UNITED STATES
NUCLEAR REGULATORY COMMISSION
WASHINGTON, D.C. 20555-0001

SAFETY EVALUATION BY THE OFFICE OF NUCLEAR REACTOR REGULATION
RELATED TO AMENDMENT NO. 214 TO FACILITY OPERATING LICENSE DPR-57
AND AMENDMENT NO. 155 TO FACILITY OPERATING LICENSE NPF-5
SOUTHERN NUCLEAR OPERATING COMPANY, INC., ET AL.
EDWIN I. HATCH NUCLEAR PLANT, UNITS 1 AND 2
DOCKET NOS. 50-321 AND 50-366

Figure 3.4.9-1 (Page 1 of 1)
Pressure/Temperature Limits for
Inservice Hydrostatic and Inservice Leakage Tests

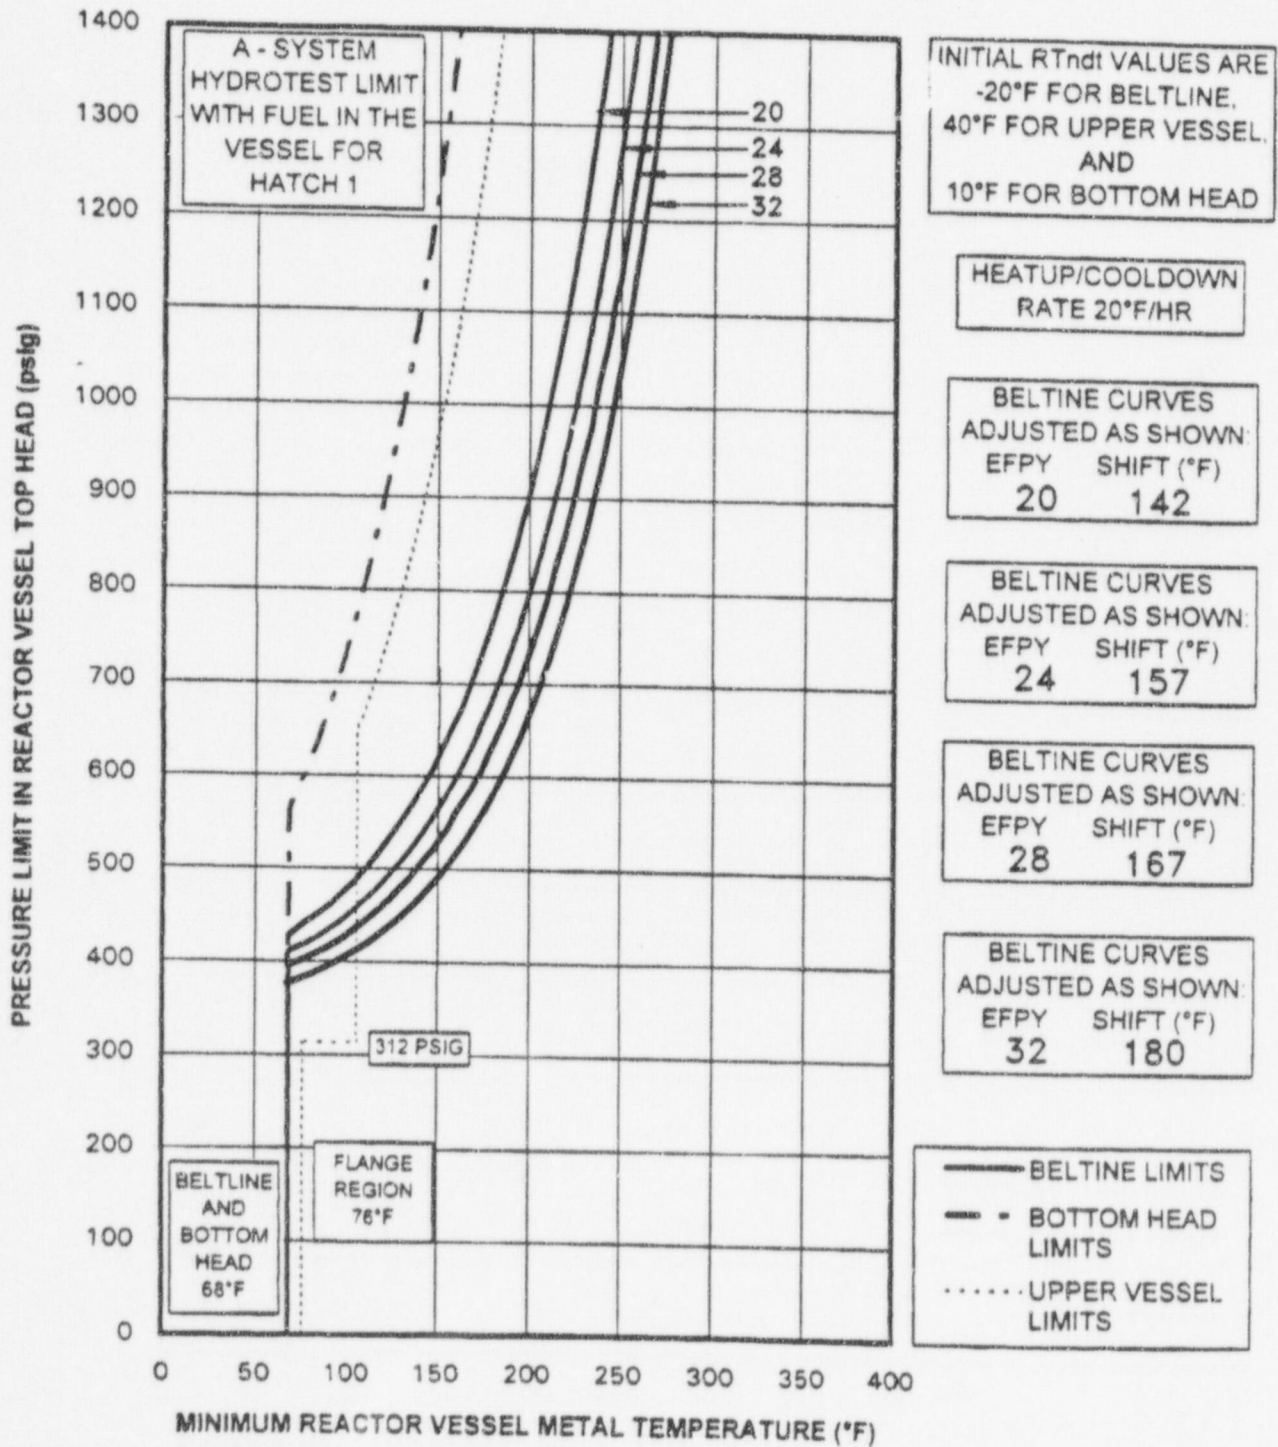
Also, given that the credible surveillance data was still being used, the margin term assigned in the analysis did not change from that in the August 19, 1997, SE. However, the fluences (and fluence factors) associated with the beltline materials at 20, 24, 28, and 32 EFPY of operation did change due to the extended power uprate. Based upon the Unit 1 fluences provided in the March 9, 1998, letter, the staff checked the heatup/cooldown, core criticality, and hydrostatic test curves provided by SNC in Enclosure 4 to the original extended power uprate submittal (Reference 1). The staff found that the curves submitted by the licensee were consistent with, or conservative to, those determined by the staff using the methodology of the 1989 Edition of the ASME Code, Section XI, Appendix G. Those portions of the curve, which were determined by consideration of the non-beltline regions of the RPV (bottom head, flange, etc.), were checked against those previously approved by the staff and also found to be acceptable. The curves approved by the staff for Unit 1, as proposed in TS 3.4.9, have been included as Figures 1, 2, and 3.

The staff has reviewed the RPV assessment provided by SNC and determined that the changes to the P-T limit curves and the changes to the upper shelf energy analyses for each unit are acceptable and that the RPV assessment addressed the changes in RPV material embrittlement due to the extended power uprate conditions. The staff has also concluded that the extended power uprate does not necessitate any change in the Hatch Unit 1 or Unit 2 10 CFR Part 50, Appendix H, RPV surveillance program.
